SUBJECT: Forwards response to questions in 781107 ltr from A
 Schwencer re addl info on containment sumptest. Sump mod is
 tentatively sched for first & fourth refueling outage for
 Unit 2 & Unit 1, respectively.

Donald C. Cook Nuclear Plant Unit 1 and 2
Docket Nos. 50-315 and 50-316
License DPR Nos. 58 and 74

RESPONSES TO NRC REQUEST FOR ADDITIONAL
INFORMATION ON CONTAINMENT SUMP
DESIGN AND TESTING

D. C. COOK PLANT
NPSH_R vs. NPSH_A

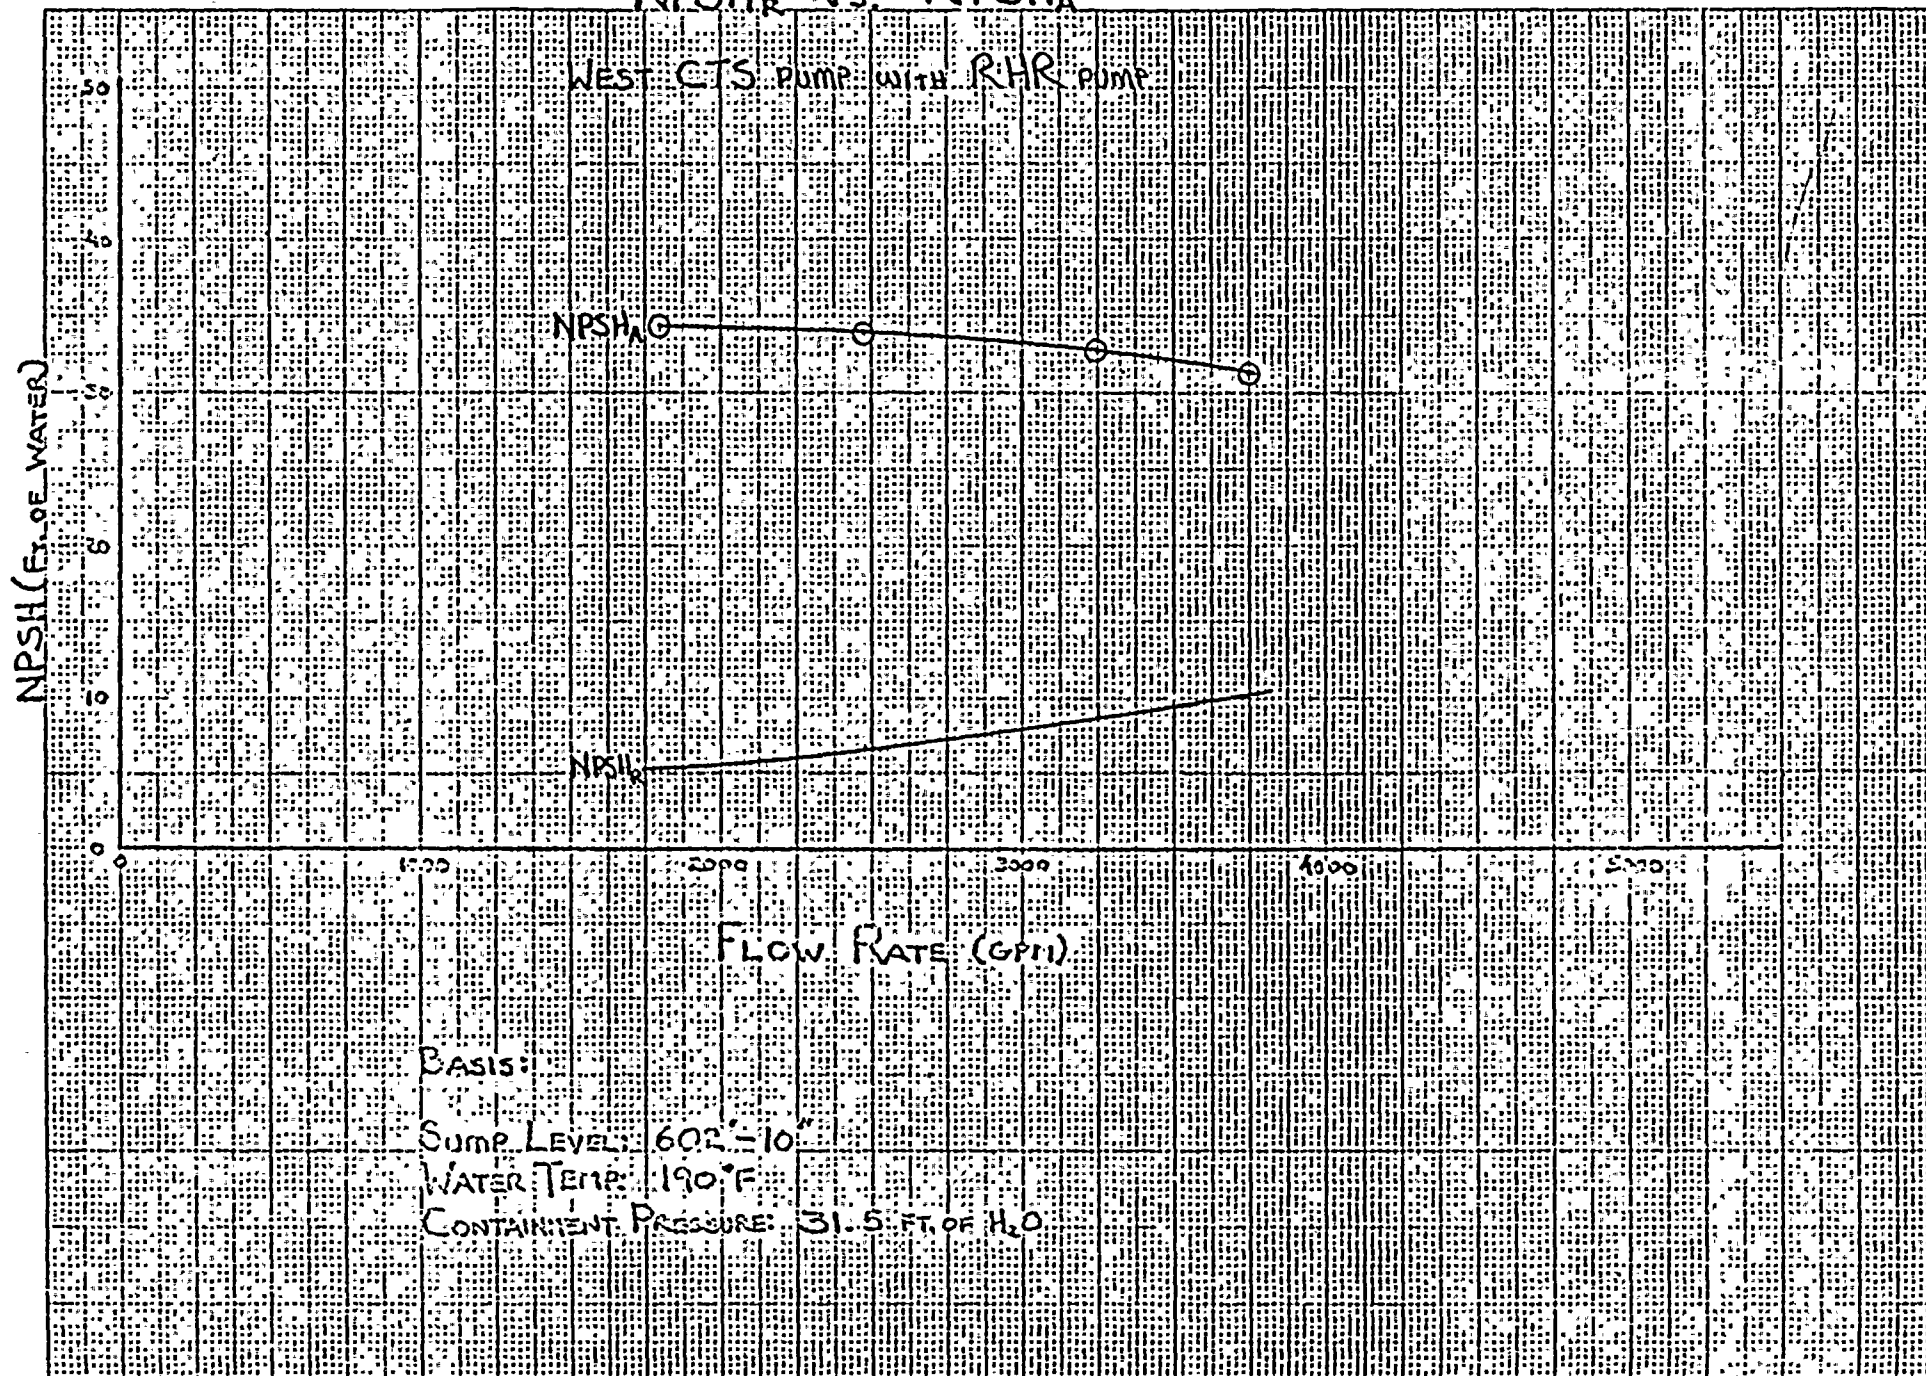
Attached is an analysis based on preoperational data and model tests which demonstrate that adequate NPSH margin is available under runout conditions for the containment spray and residual heat removal pumps.

Demonstrate that adequate NPSH margin is available under runout conditions for the Containment Spray (CTS) pumps and the Residual Heat Removal (RHR) pumps. Entrance losses based on model tests and pipe friction losses based on preoperational tests will be utilized.

IN ALL CASES THE NPSH_A EXCEEDS THE NPSH_R . AS IS SHOWN ON THE TABLES AND GRAPHS ON THE FOLLOWING PAGES.
